**Proposed Rezoning of the Site from “Other Specified Uses” annotated “Business” to “Other Specified Uses” annotated “Residential Care Home for the Elderly and Hotel”
for a Proposed Composite Development with RCHE and Hotel
at Nos. 107 – 109 Wai Yip Street, Kwun Tong
(Planning Application No. Y/K14S/4)**

Response-to-Comment Table

(Planning Application No. Y/K14S/4)

Figure 2.2

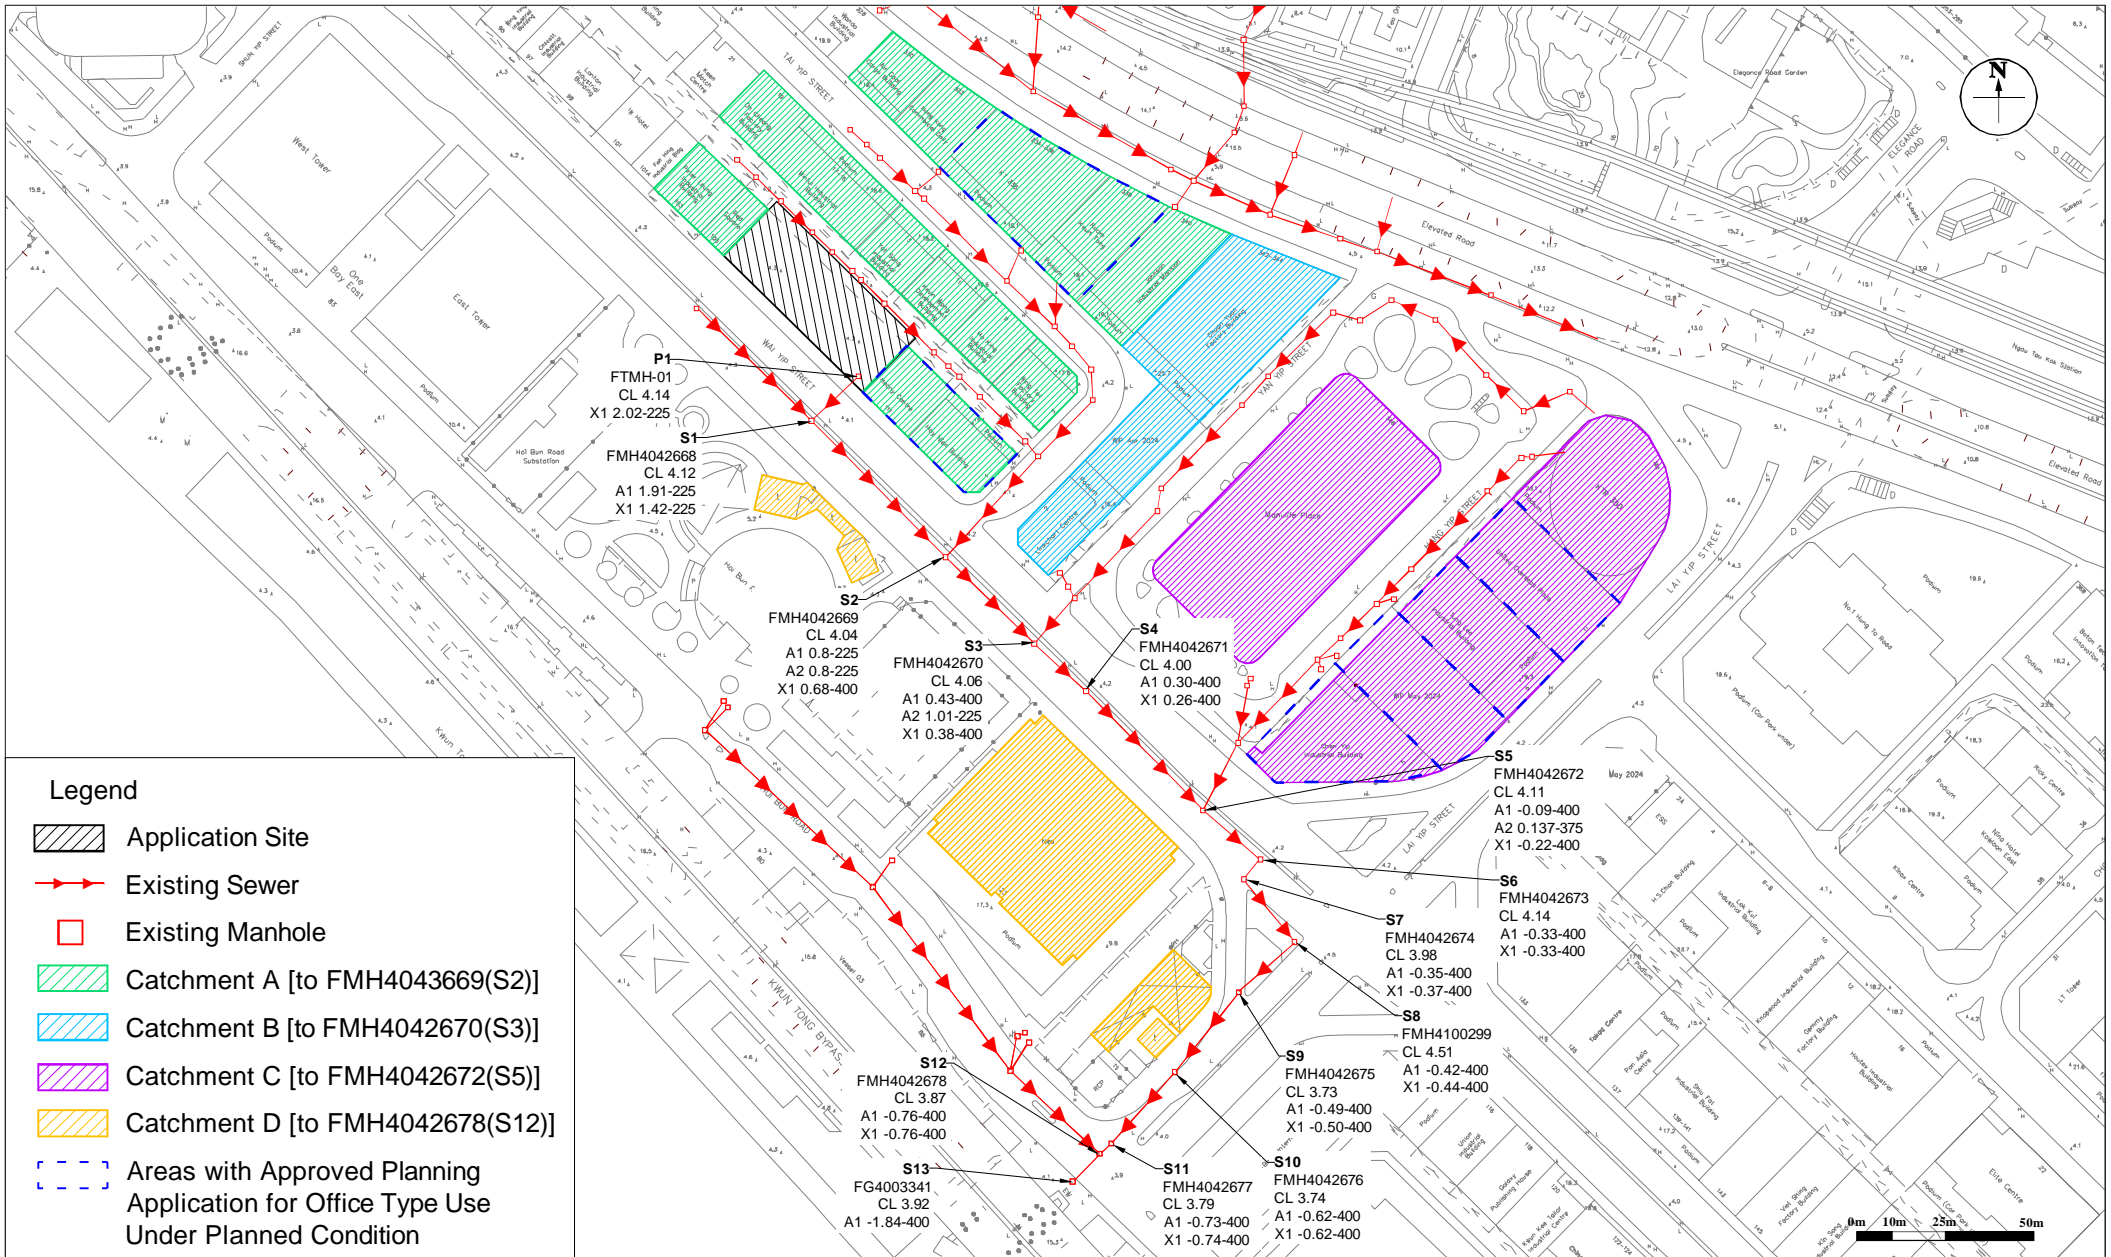
| Comments | Summary & Response/Action |
|---|--------------------------------|
| 3. Figure 2.2 : Please review the legend for Catchment A, S2 should be referring to FMH4042669 instead of FMH4043669. | Figure 2.2 has been revised. |

Figure: 2.1

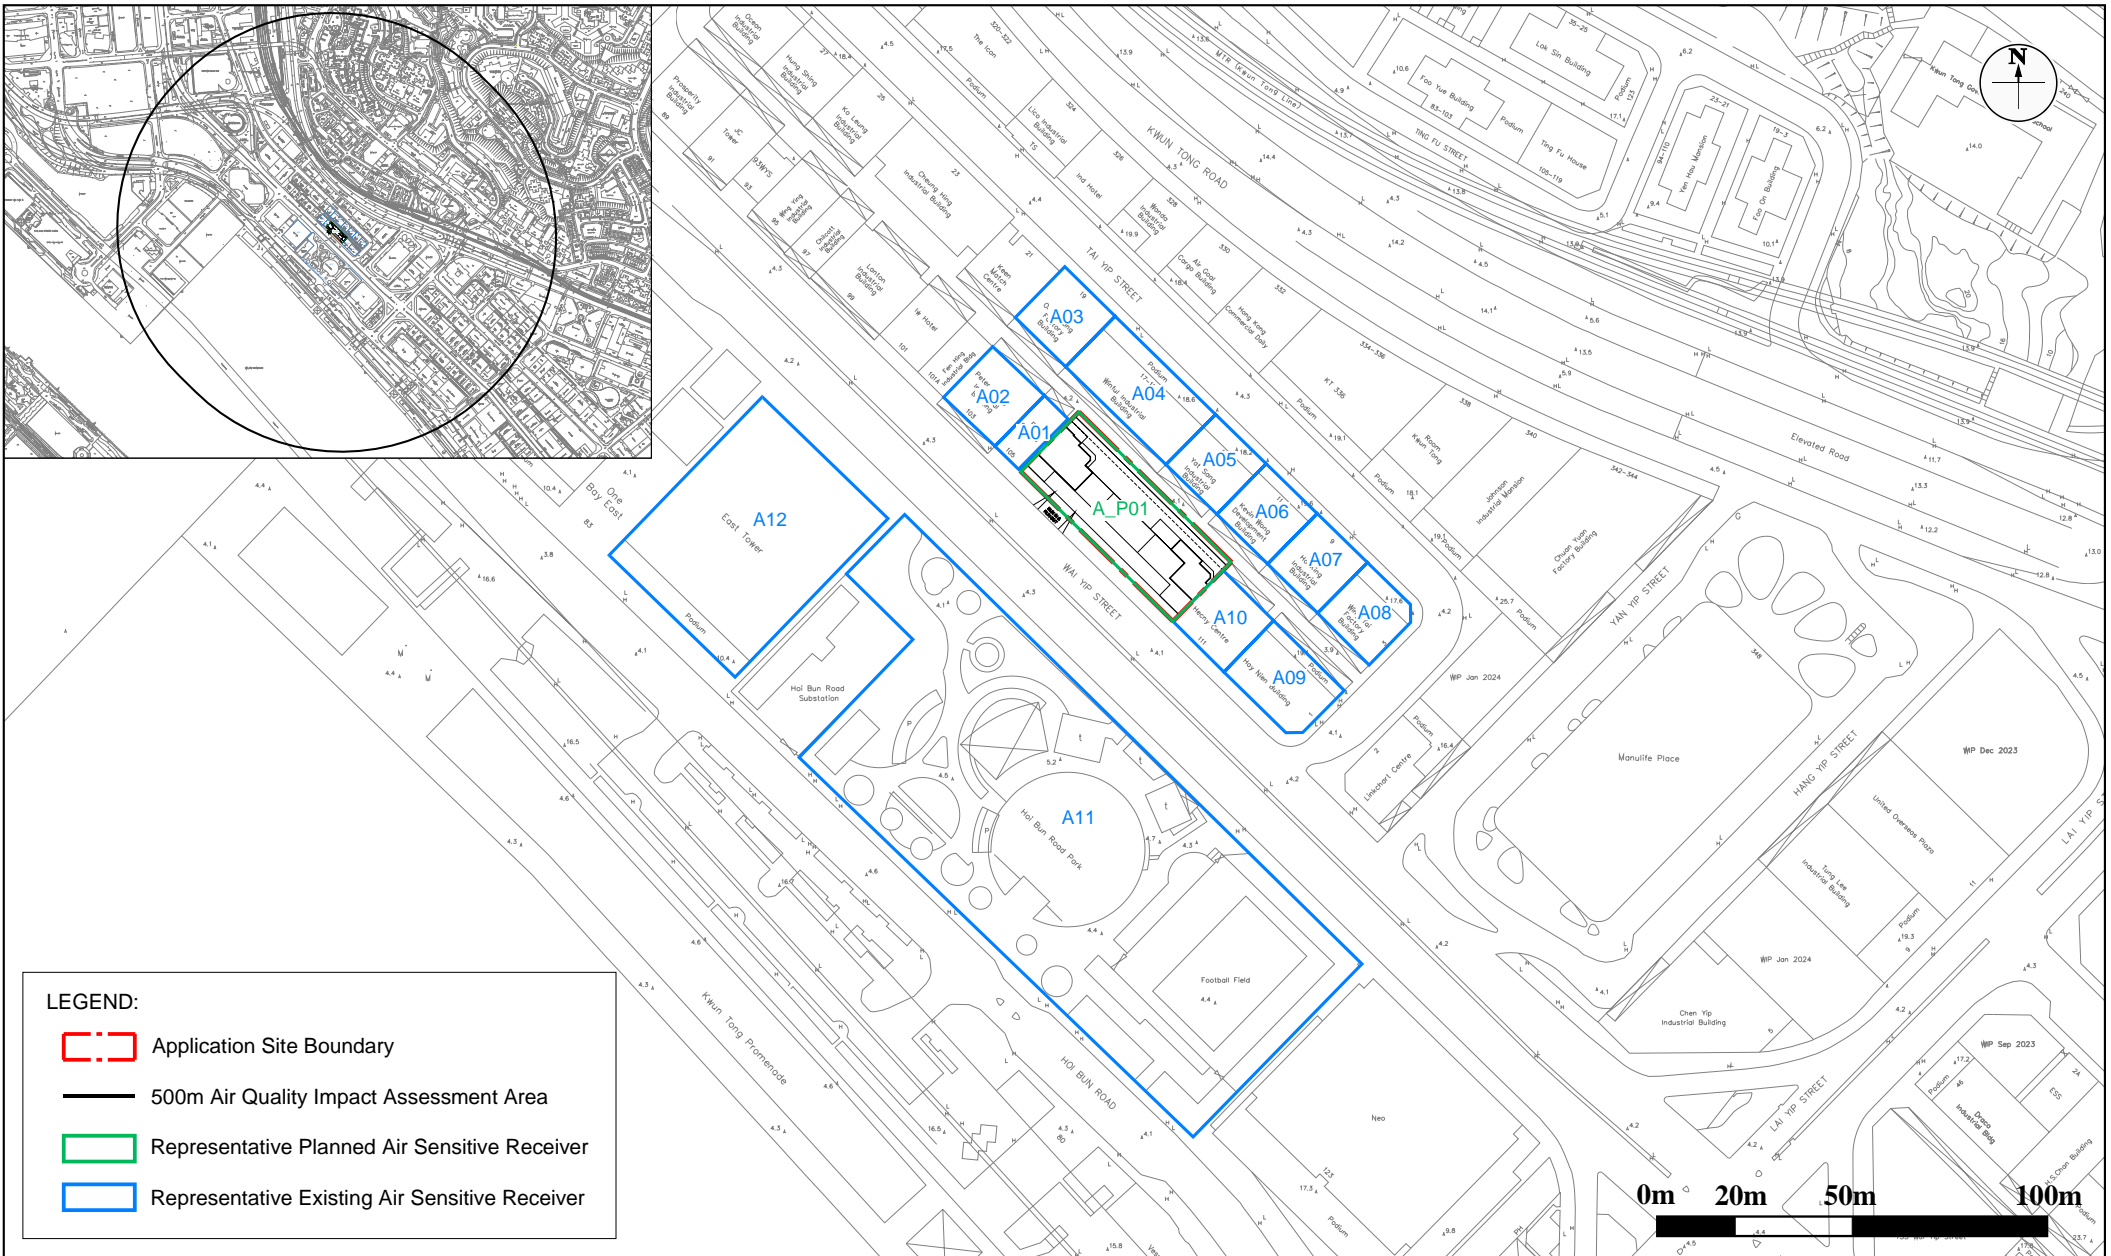
| Comments | Summary & Response/Action |
|---|---|
| <ul style="list-style-type: none"> • A table listing the details of representative ASRs and a corresponding figure indicating their locations | Details of representative ASRs have been provided in Section 2.4 and Figure 2.1. |

HOTEL TYPICAL FLOOR PLAN SK-9 6 FEBRUARY 2025

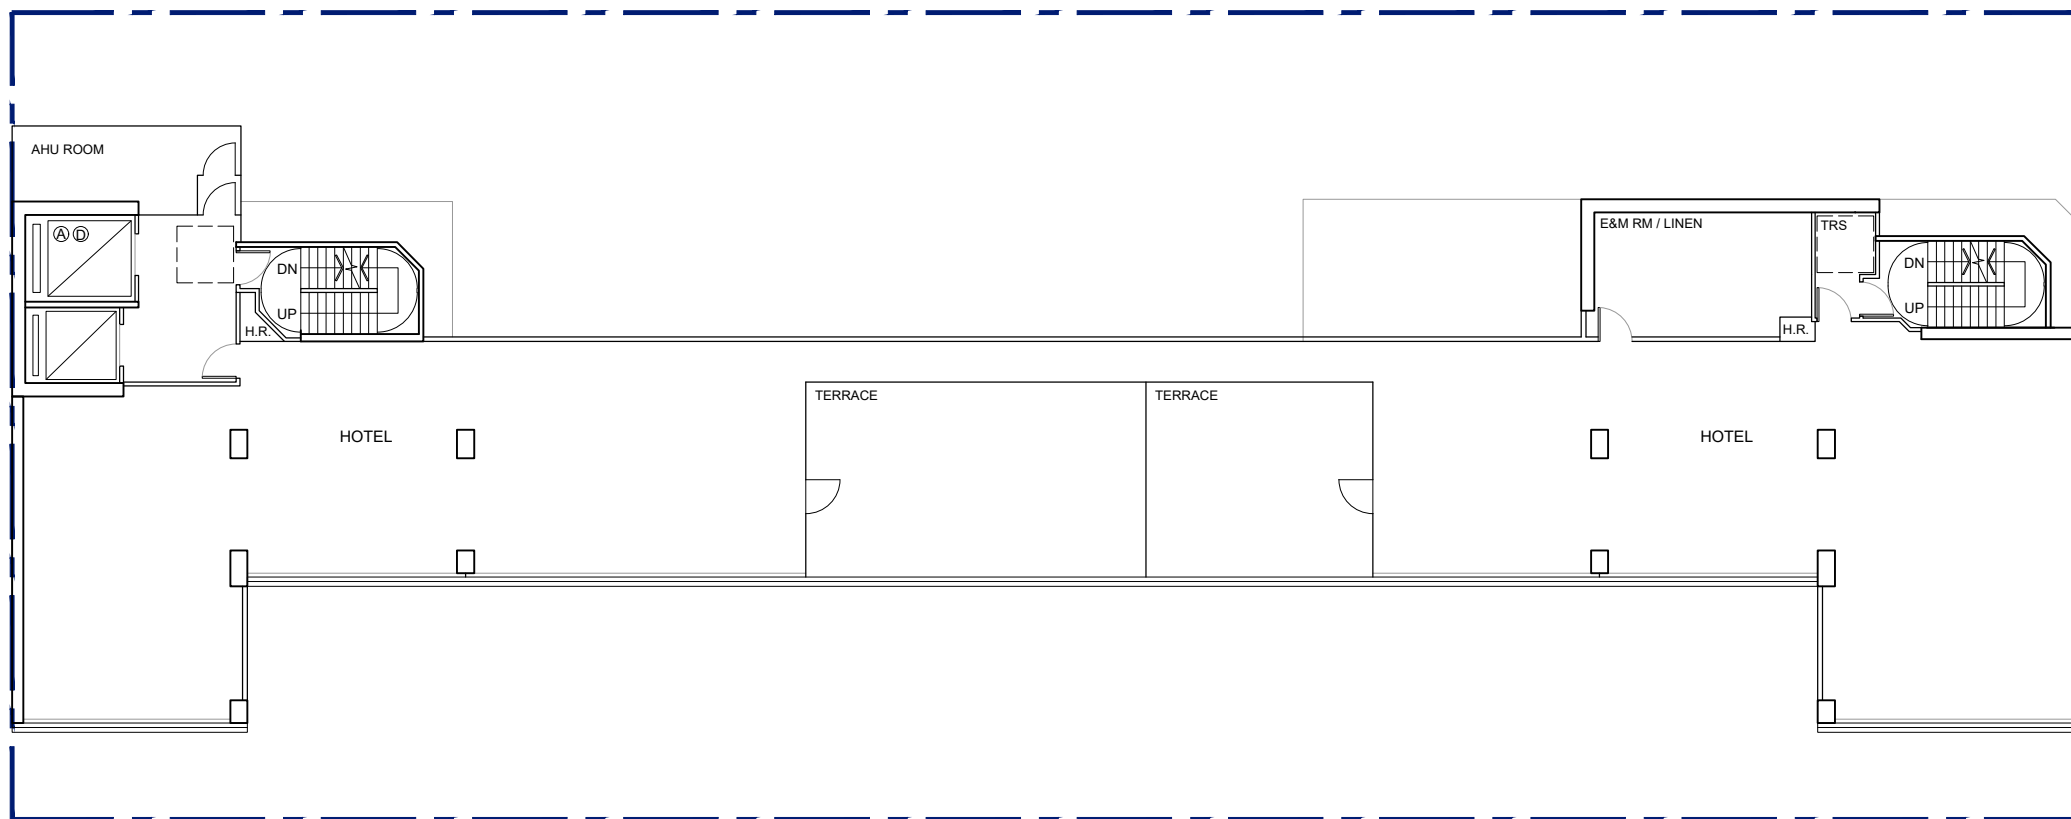
| Comments | Summary & Response/Action |
|---|---|
| <p>6. Furthermore, according to the Appendix 1 Indicative Development Scheme, it provides RCHE typical floor plans and hotel typical floor plans, please also provide the RCHE and hotel typical floor plan with room layout for our consideration. Please also supplement the number of elderly in each room.</p> | <p>Please refer to the revised drawing no. SK-7B for typical room layout for RCHE and number of elderly in each room.</p> <p>Please refer to the revised drawing no. SK-9 for typical room layout for hotel.</p> |
